**RESOLUTION 32514 OF THE BOARD OF DIRECTORS OF
CASAS ADOBES TERRACE HOMEOWNERS ASSOCIATION (CATHOA)
RELATING TO TREES IN LOT SIDE BUFFER YARDS**

DATE: November 18, 1992
TO: Deborah Marchbanks, Subdivision Coordinator
FROM: George H. Richard, Principal Planner *GHR*
RE: CO12-92-36
CASAS ADOBES TERRACE
PRESERVATION PLAN AND LANDSCAPE PLAN

RE: CO12-92-36,
CASAS ADOBES TERRACE, LOTS 1-184
REVISED LANDSCAPE PLAN

Casas Adobes Terrace
LANDSCAPE PLAN NOTES AND DETAILS

Detail #3
Typical Side Yard Bufferyard C

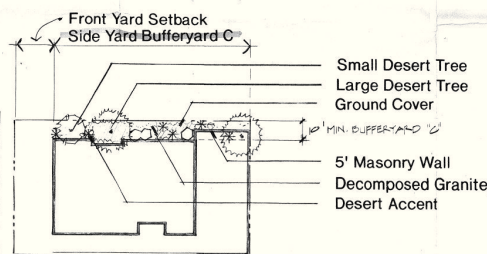
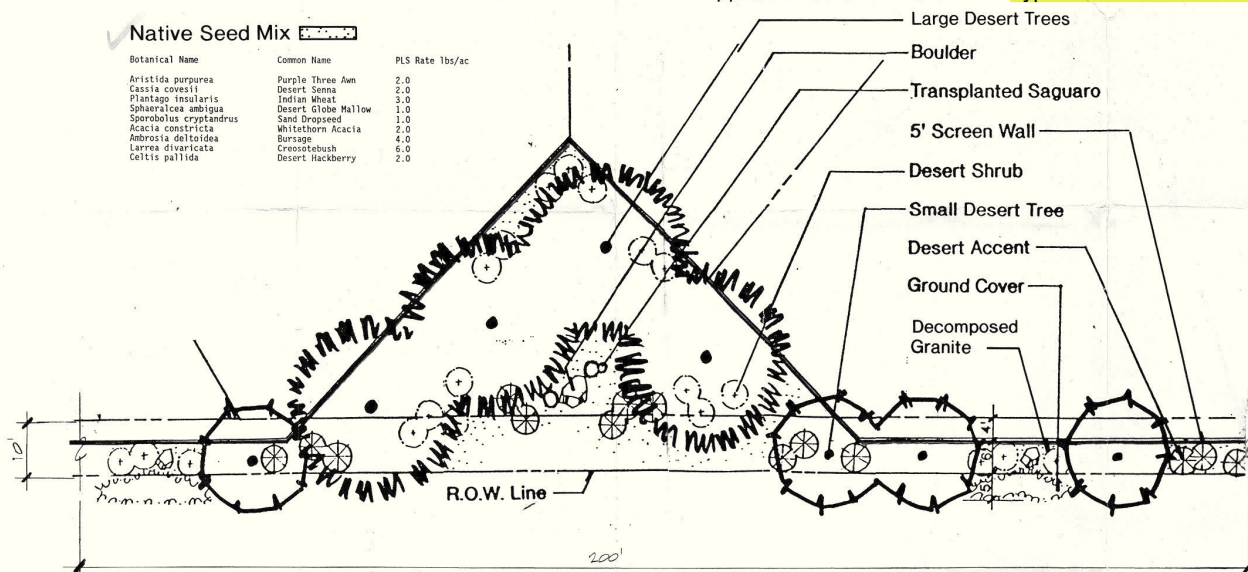
1. Please delineate and specify the required bufferyards "C" (sideyard elements and dimensions) for the following numbered lots, whose sides abut internal public streets:
 - * Sheet 3 of 7: Lots 3,7,8,145,157,158,171,174;
 - * Sheet 4 of 7: Lots 13,14,29,33,34,38,39,58;
 - * Sheet 5 of 7: Lots 98,100,101,114,116,128,129,143;
 - * Sheet 6 of 7: Lots 59,72,75,104,106,110.
2. Please provide a detail of the typical side yard "C" for the lots listed above.
3. In reference to your note #1, Sheet 7 of 7, please indicate the method to be used which shall insure that individual lot owners will install the required bufferyards. The installation of bufferyards is meant to be the responsibility of the developer, so that the subdivision can benefit from design integrity and quality construction. Controls must otherwise be in place to insure conformance.
